## **BOARD OF SUPERVISORS PUBLIC HEARING**

DATE OF HEARING: May 9, 2011
ZMAP 2006-0026 Lambert Property
DECISION DEADLINE: February 25, 2012
PROJECT PLANNER: Marchant Schneider DIRECTOR: Julie Pastor
ELECTION DISTRICT: Dulles

#### **EXECUTIVE SUMMARY**

Figure 1. Concept Development Plan

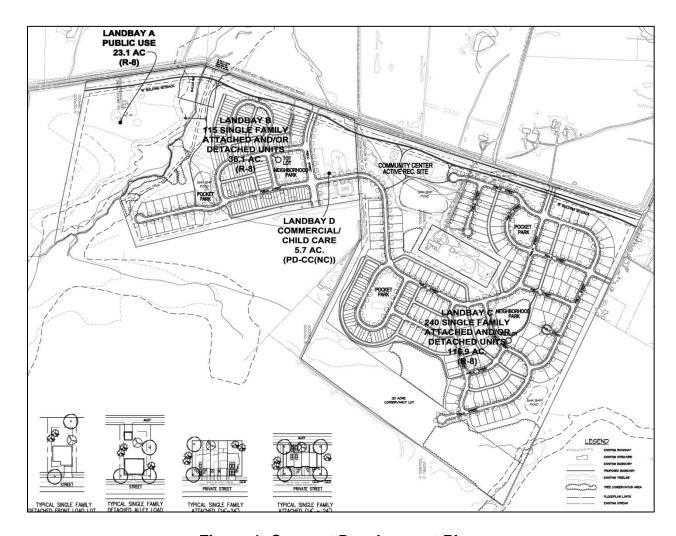
The proposed project is separated into four landbays (A through D) in an effort to meet the characteristics of a Countryside Village. Landbays are described below, moving from north to south (see Figure 1 below):

Landbay A: Proposes as a 23.1-acre public use site. Approximately 8.8 acres are comprised of stream corridor resources, including approximately 6.3 acres of floodplain and 2.5 acres of scenic creek valley and management buffers, leaving approximately 14.3 acres for the construction of a school or other public facilities. The landbay also contains an historic cemetery.

- Landbay B: Proposes 115 residential units. The landbay also contains a pocket park and a neighborhood park, which includes a tot lot.
- Landbay C: Comprised of 240 units, a 9.5-acre community center and recreation site, 2 pocket parks, a neighborhood park, and a 20-acre conservancy along the western boundary. The landbay surrounds an approximately 6.3-acre outparcel containing a residence and landscaping business. The draft proffers state that the community center would be a minimum of 1,500 square feet and contain a minimum 25-meter pool.

- Landbay D: Proposes a 5.7-acre site which will contain a day-care facility and a
  neighborhood commercial center. It is intended to meet the service and retail needs
  of the immediate community. The Applicant has requested a zoning modification to
  increase the combined maximum floor area for these facilities from 25,000 square
  feet to 40,000 square feet.

Overall, the size of the site, approximately 190 acres, does not support the types of uses envisioned within a Countryside Village. The PD-CV (Planned Development – Countryside Village) zoning district was developed to implement the Countryside Village policies of the Plan while the Applicant is seeking a rezoning to the PD-H3 (Planned Development – Housing) zoning district. The PD-CV zoning district calls for a district size of no less than 500 acres with incremental and contiguous additions of land. The Applicant has made an effort to implement the design objectives envisioned by the Plan for a Countryside Village; however, due to constraints associated with the site, a Residential Cluster is more appropriate in this location. Staff notes that developments to the south are 1 dwelling unit per acre (Dawson's Corner) and 1 dwelling unit per 3 acres (Cedar Crest), which would be compatible with the Residential Cluster option. If the property were to be developed with residential clusters, it would yield approximately 63 units. Staff recommends the Applicant seek a Residential Cluster.
